1st Further Information

Proposed Temporary Private Vehicle Park (Heavy Goods Vehicles) and Open Storage of Construction Materials and Machinery with Ancillary Facilities and Associated Filling of Land for a Period of 3 Years in "Agriculture" Zone and area shown as 'Road', Lot 1095 in D.D. 82, Ta Kwu Ling, New Territories

(S.16 Planning Application No. A/NE-TKL/856)

(i) The applicant would like to submit a response-to-comments table for the consideration of government bureaux/departments:

LANDSCAPE PROPOSAL

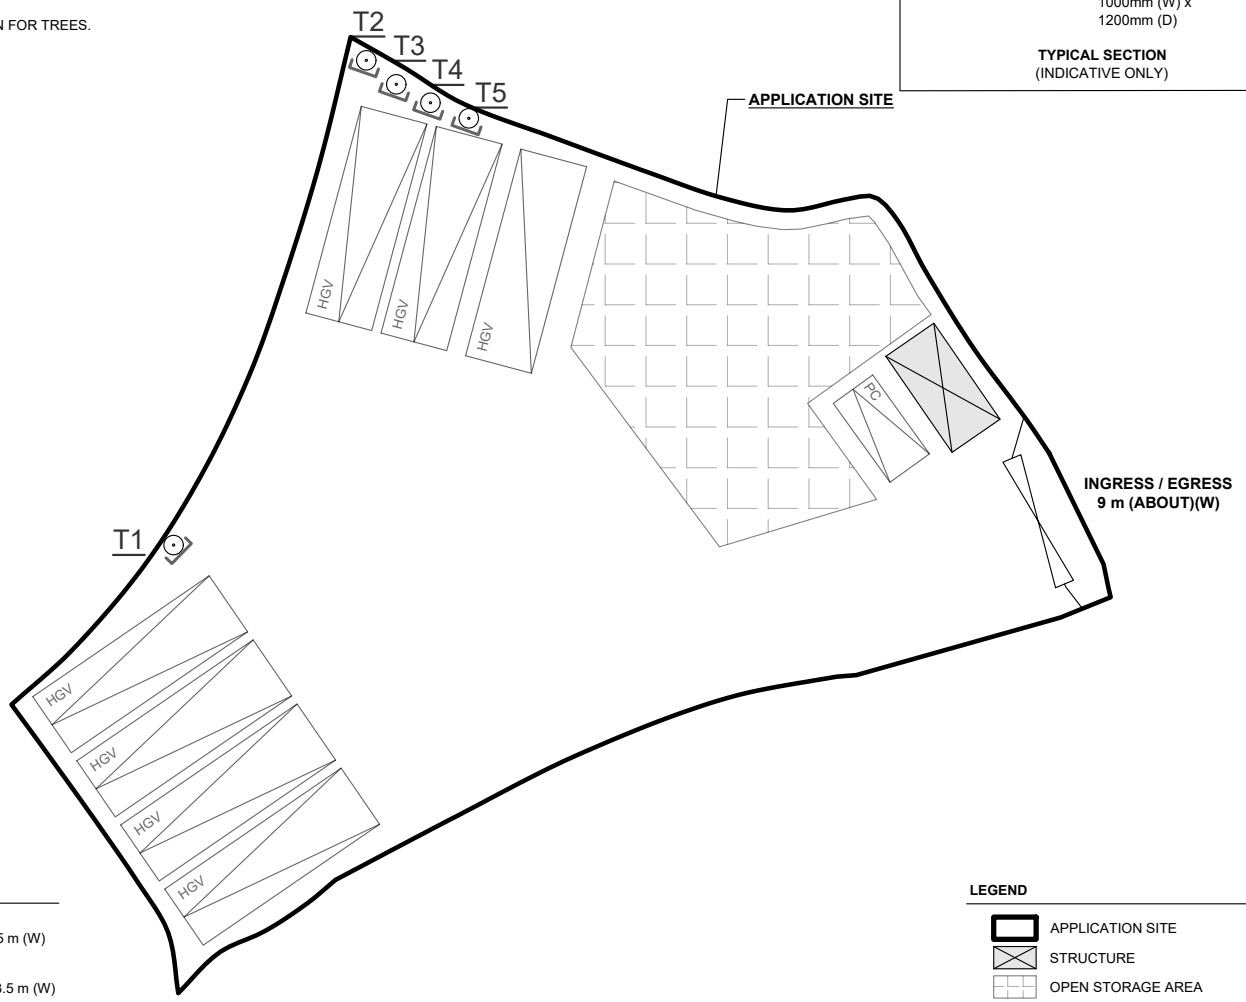
(1)	As noted on Plan 6, land filling of the whole site is proposed which may lead to tree felling. This contradicts the Application Form which states that no tree felling will be involved. Please review and clarify.	According to a tree survey conducted by the applicant, 5 nos. of trees were identified within the site boundary. No OVT or protected species has been identified. Due to land filling in the Site, all identified trees are proposed to be felled. A landscape proposal is provided by the applicant (**Appendix II**) where 5 new trees (i.e. Bauhinia Blakeana) (T1 to T5) are proposed to be planted at the southeastern portion of the Site as a landscape buffer. The proposed 5 new trees will be planted at least 1.2m soil depth for better tree health. The new proposed trees are for mitigating any potential visual and landscape impact (if any) towards nearby sensitive receivers. The new trees planted within the Site will be maintained by the applicant in good condition during the planning approval period.

SWEPT PATH ANALYSIS (HGV)

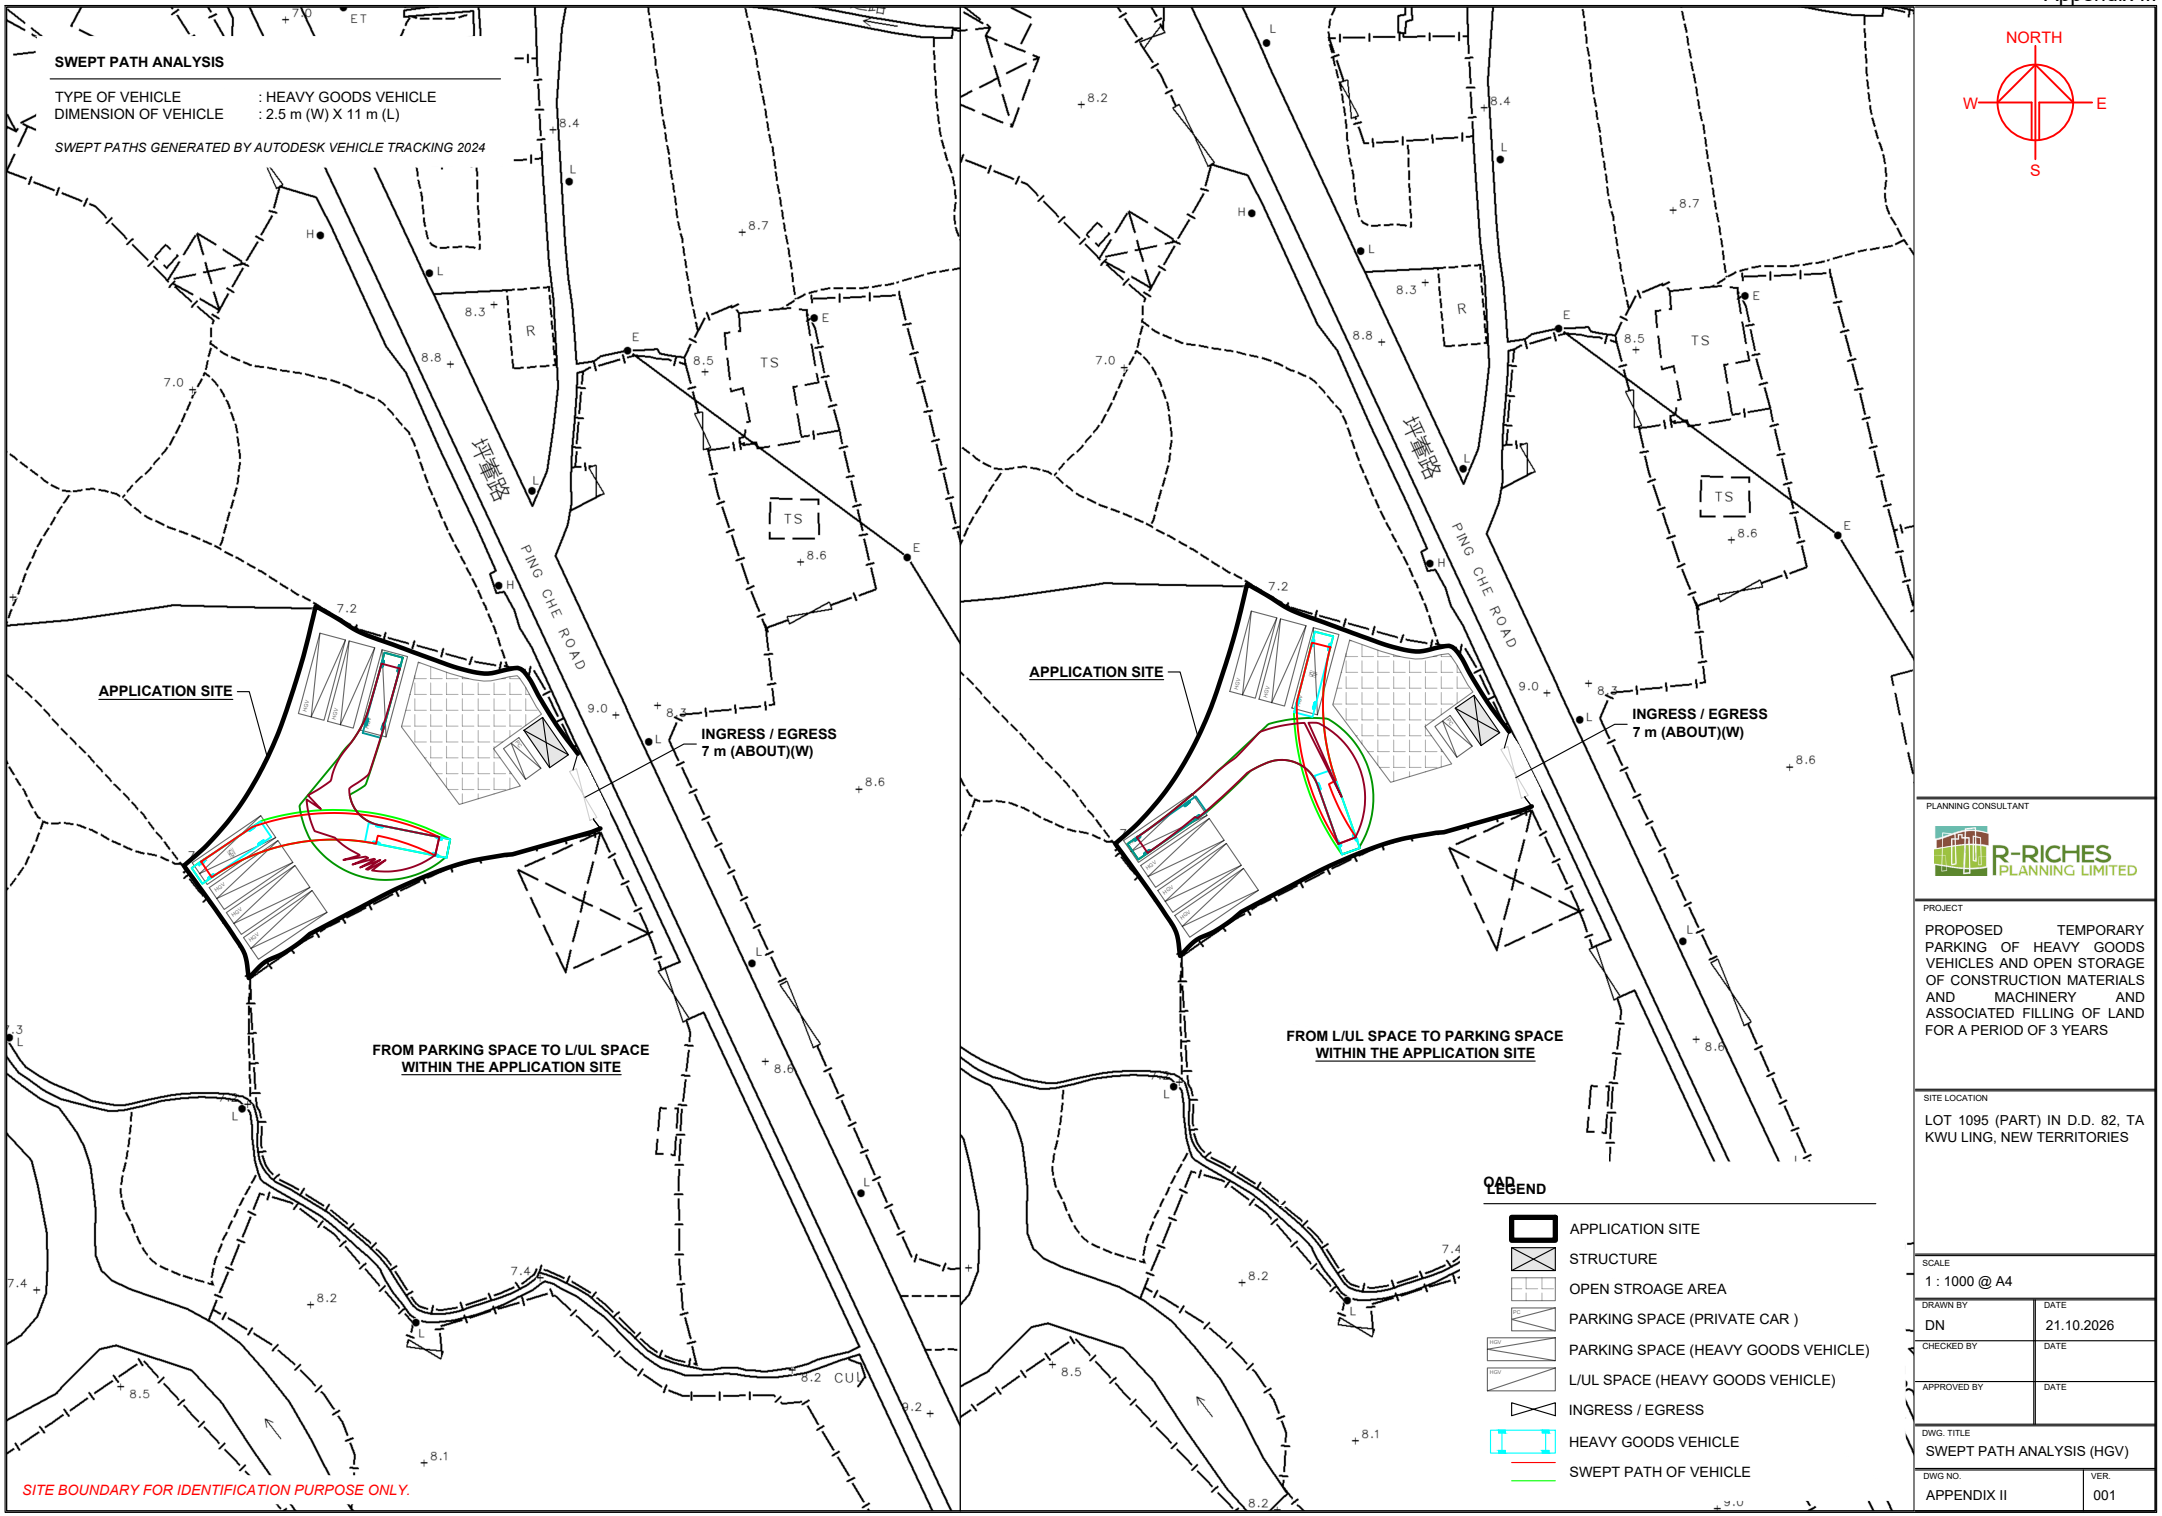
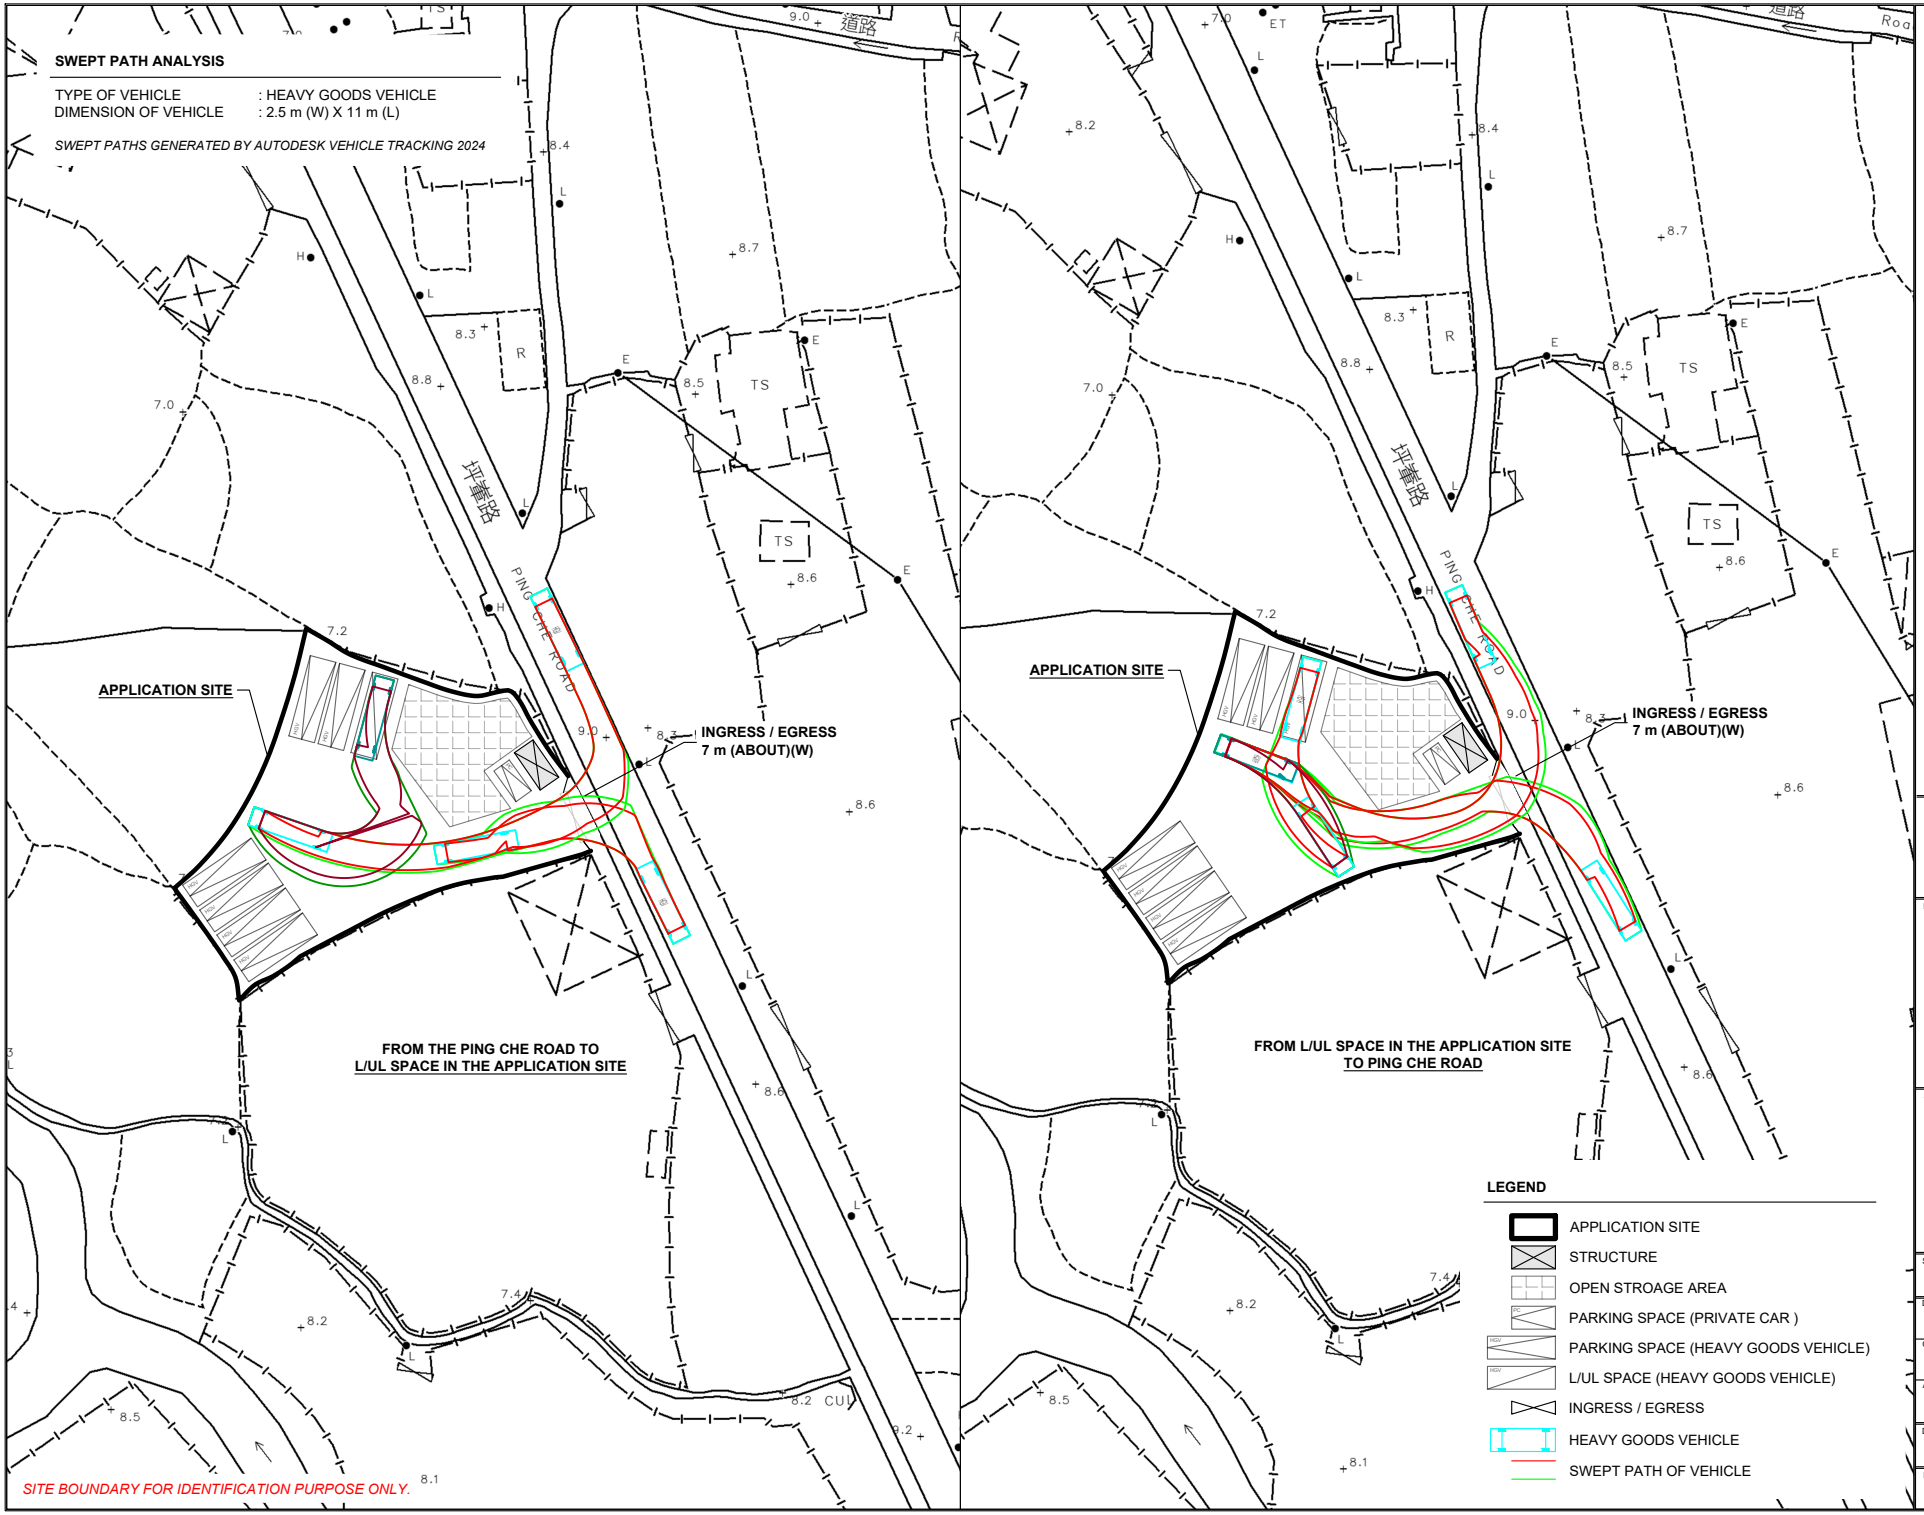
Comments of the Commissioner for Transport (C for T) (Contact Person: Mr. Yvette LI, Tel.: 2835 2390)		
(1)	The applicant shall demonstrate the manoeuvering of the heavy goods vehicles manoeuvering within the shaded parking and loading/unloading spaces in Appendix I and entering/leaving Ping Che	Noted. Please find swept path analyses at **Appendix III**. The swept path analyses have demonstrated that sufficient spaces are provided for heavy

Road to/from the application site without encroaching opposite lane;	goods vehicles to manoeuver within different parking and loading/unloading spaces within the Site and entering/leaving the Site.
